RE: NR-628 D-118-S

Enclosed please find the information you requested concerning the model 865 device listed in your letter dated 17 July 96. I have responded to the questions in the same order as your letter.

FIG. 1

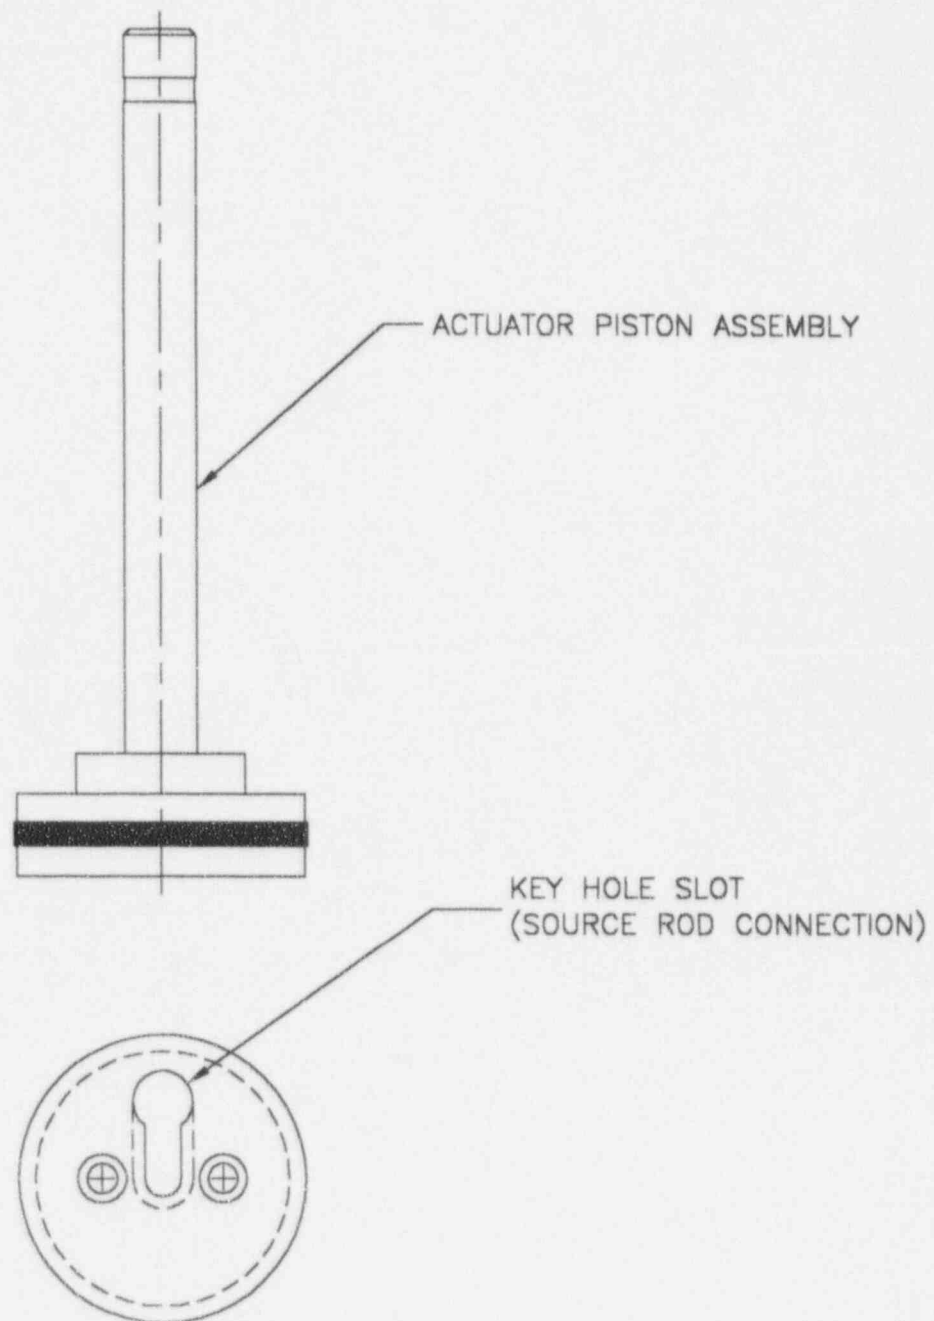
- 1) Figure 1 shows the keyhole slot.
- 2) Figure 2 shows the four hex head bolts holding the actuator assembly to the device and the method of securing the source holddown cap to the device.

FIG. 3

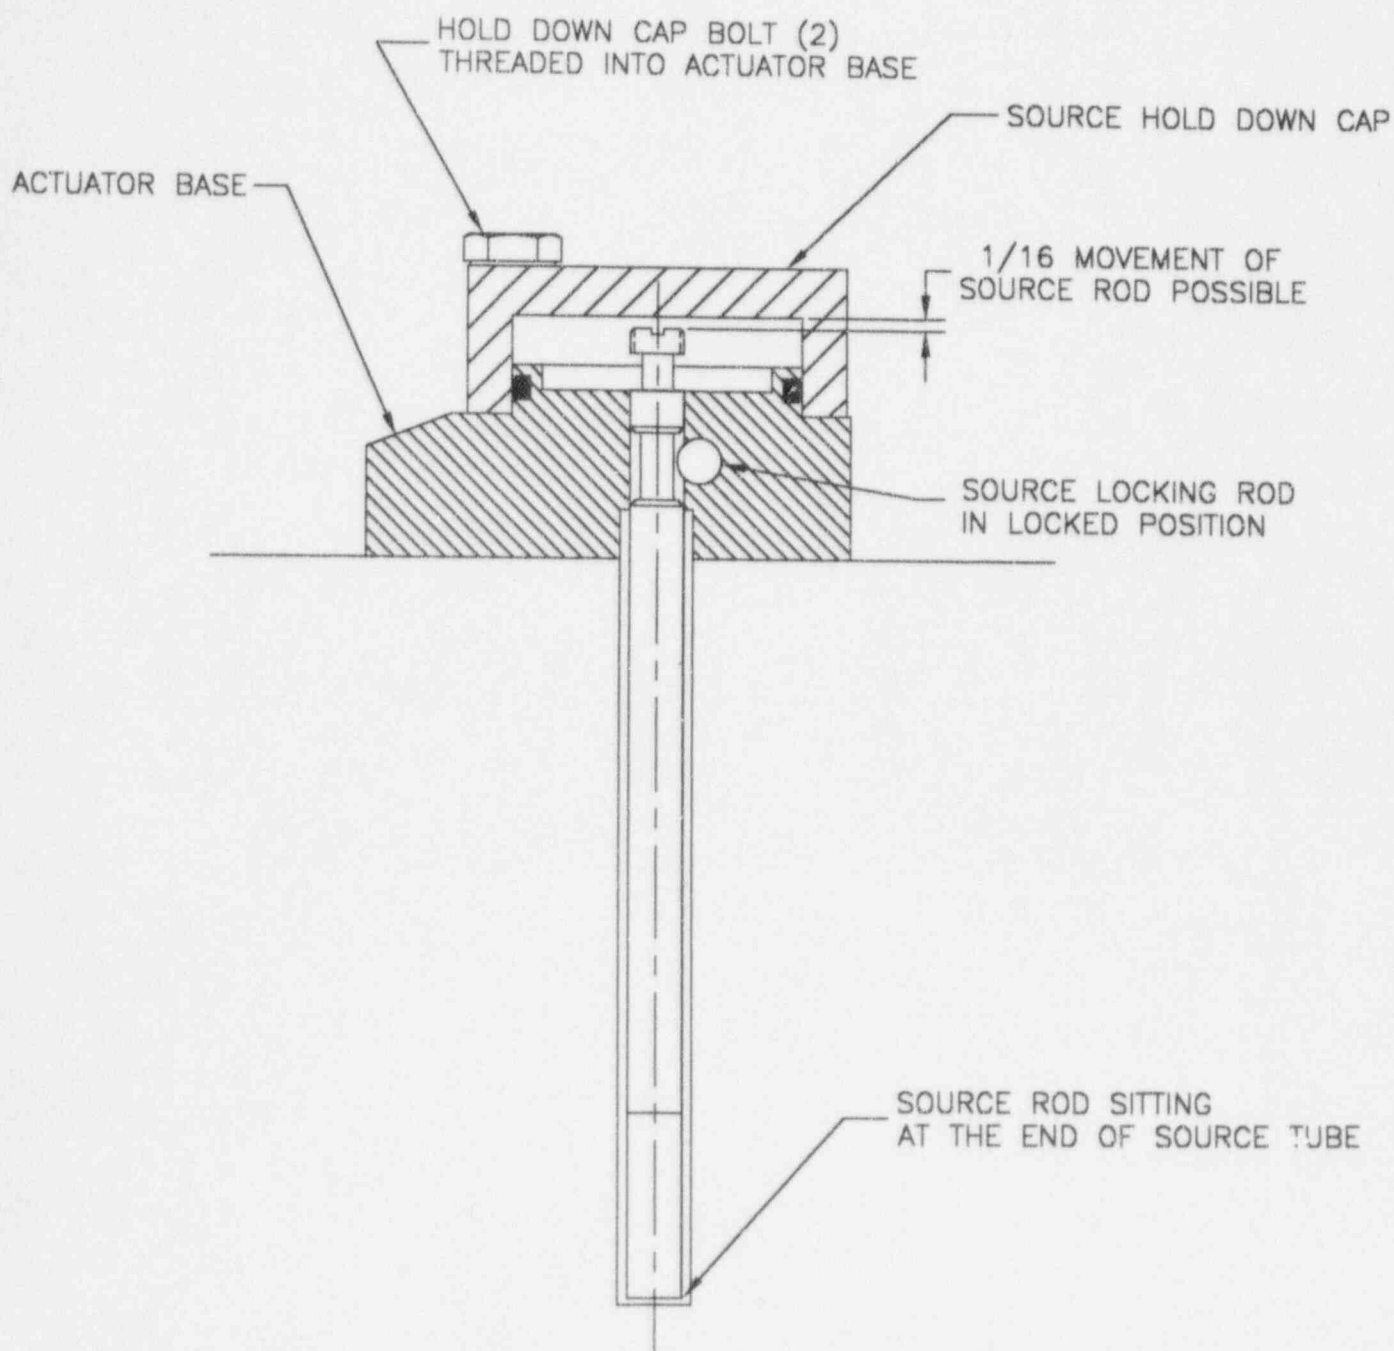
- 3) Figure 3 shows the holddown cap in position during performance of maintenance, as can be seen the only possible movement of the source rod is approximately 1/16 inch. This allows the source to remain locked during the performance of the maintenance and when the source holddown cap is removed the source stays in the locked position.

FIG. 4

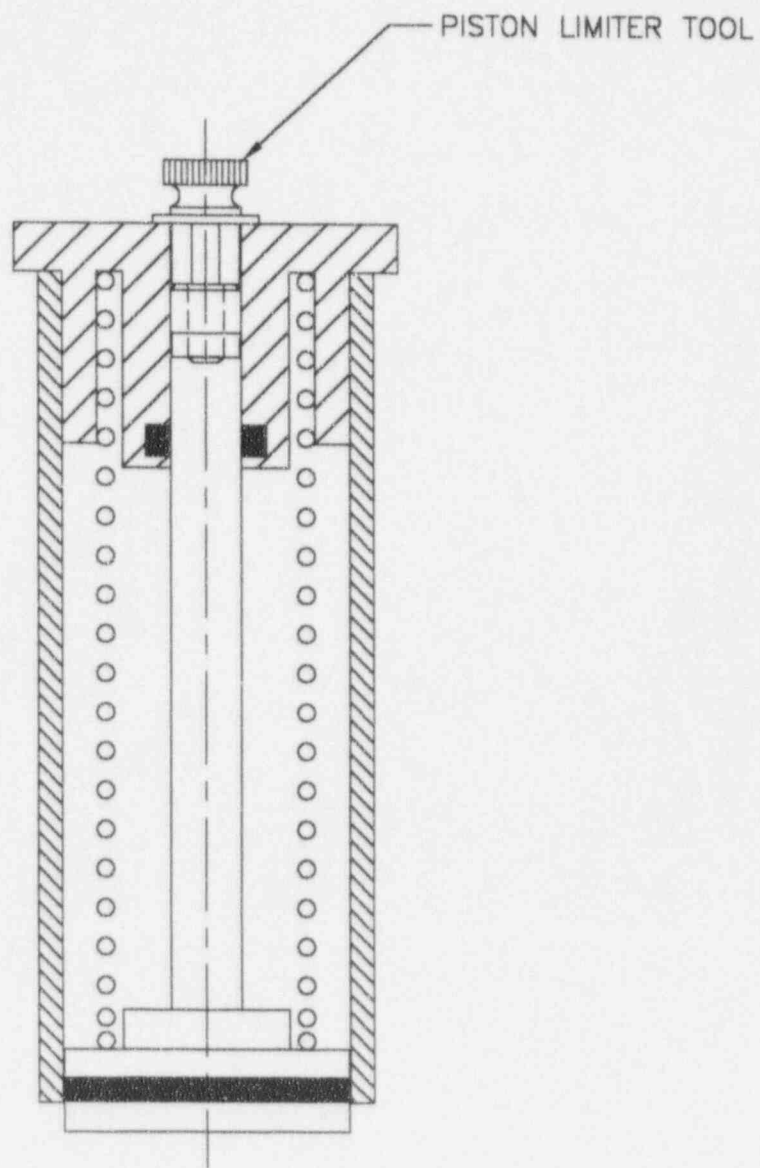
- 4) The piston limiter tool is shown in use in Figure 4 and is designed to keep the actuator assembly together during the removal of the actuator from the body of the device. It does not lock the source in the stored position, the source locking rod in Figure 3 does this. The statement in the letter dated 24 May 1996 was inaccurate in the description of the tool's function, due to a misunderstanding of the engineering description.
